City of Sunnyvale

Memo

TO:	City Council
FROM:	Mary Jeyaprakash, Project Planner
PROJECT:	800 Carlisle Way Well and Water Tank Project (2022-0741) Response to Late Comments on EIR
AGENDA ITEM:	3
DATE:	July 16, 2026

This supplemental staff memo addresses questions and comments on the Focused Environmental Impact Report for the project that the City received after the Planning Commission meeting on March 9, 2026.

Source: City of Sunnyvale. 2025 Urban Water Management Plan. Adopted June 16, 2026. Figure 3-1, Page 26.

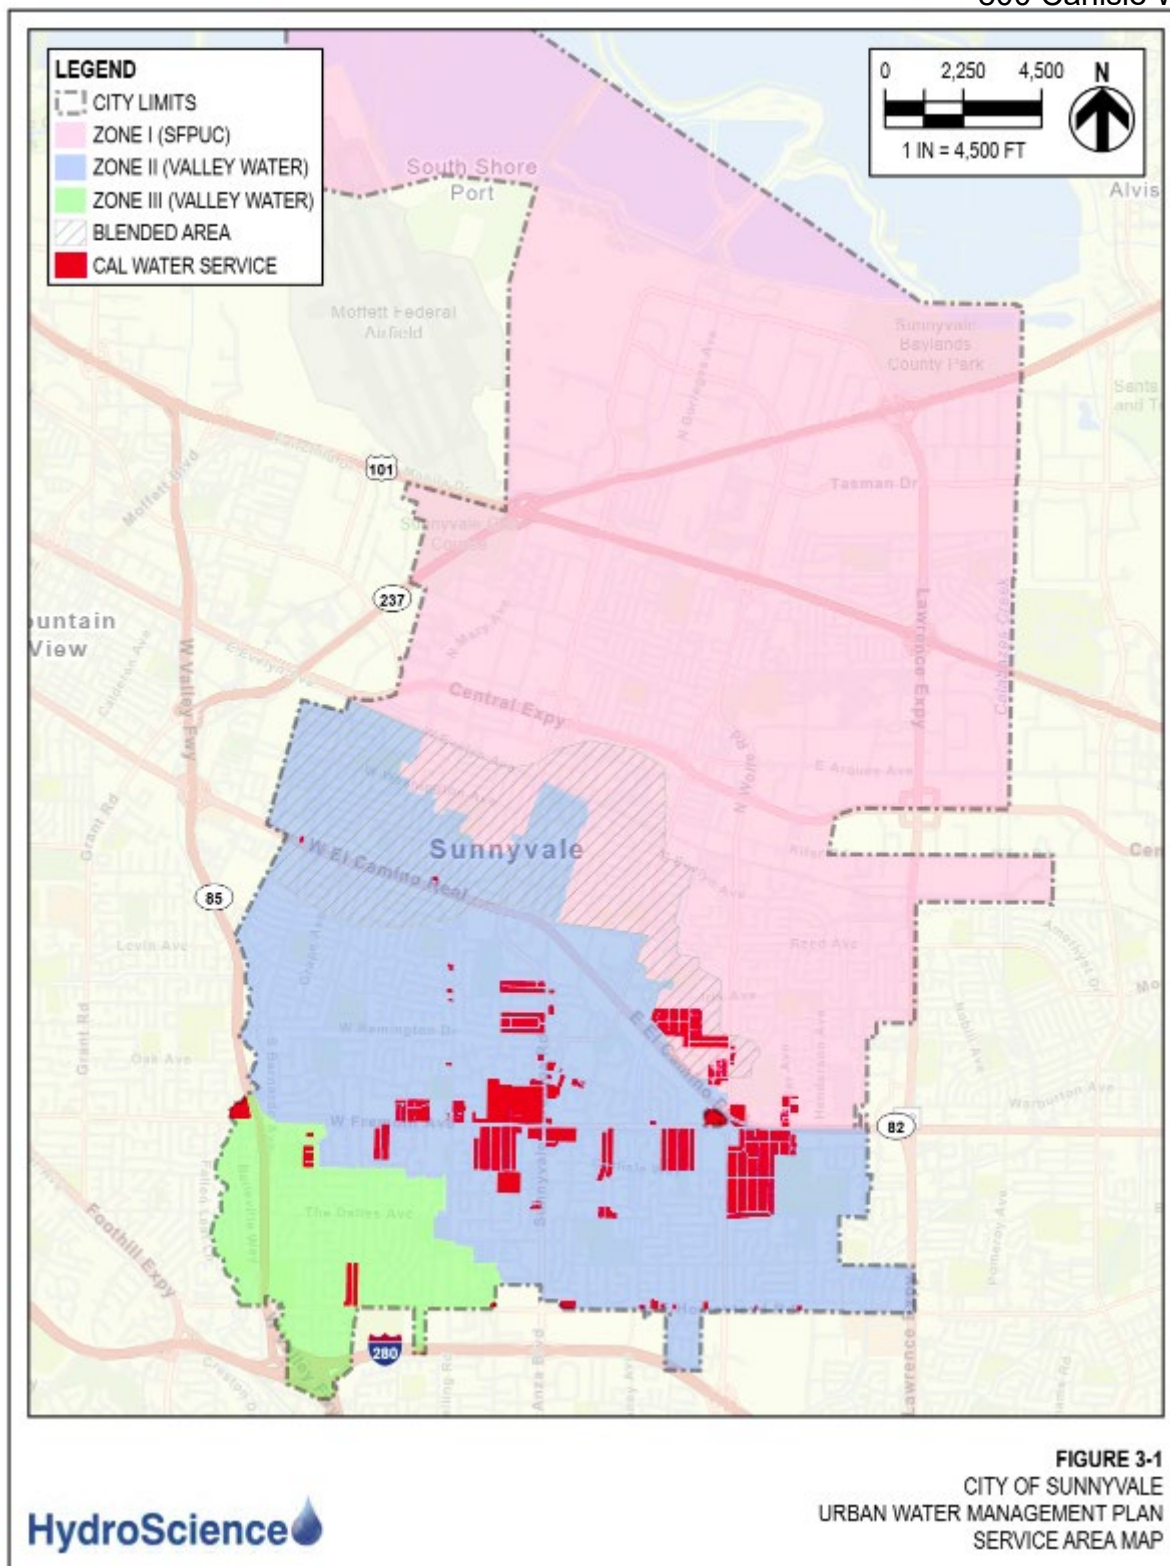
- Whether the project provides benefit to the City
- Whether impacts to the groundwater basin were considered
- Whether this well would draw water from the same supply that the City of Sunnyvale uses for their groundwater wells

Several comments were received regarding the project not providing a direct benefit to adjacent residences or the City, as Cal Water (the applicant) does not provide water to the adjacent residences. As noted on page 8 of the Draft EIR:

Figure 3-1 from the City's adopted Urban Water Management Plan has been excerpted and provided on the following page. The figure shows which entity provides water to different areas of the City. Customers within the City receiving water from Cal Water are shown in red on the figure and include residents on the north side of Carlisle Way.
